## BULLETIN NO 107/94 SWIFT

Ref: Radio cable layout improvement

Zakład Remontów i Produkcji Sprzętu Lotniczego  
Edward Margański, Bielsko-Biała

Fig. 1.

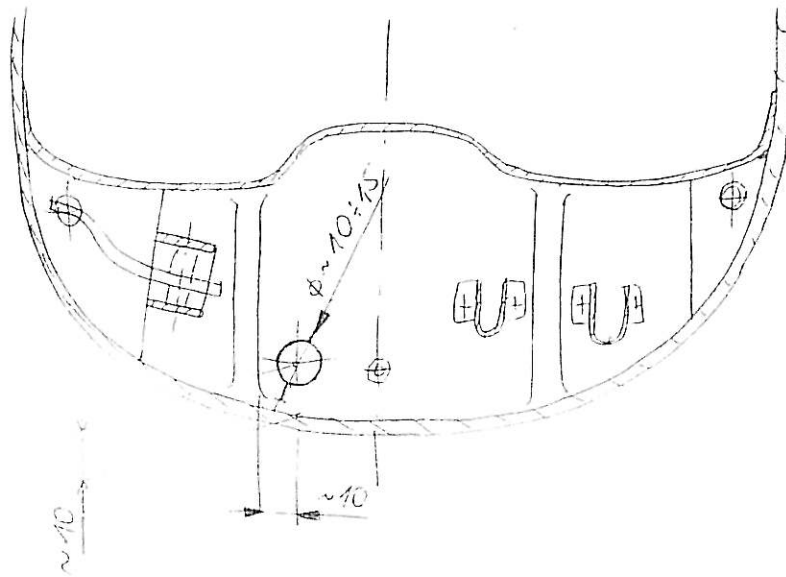
There is a possibility to improve the radio cable layout through drilling small holes in both walls - before and behind the control stick (look Fig.1) and let the cable run through them.
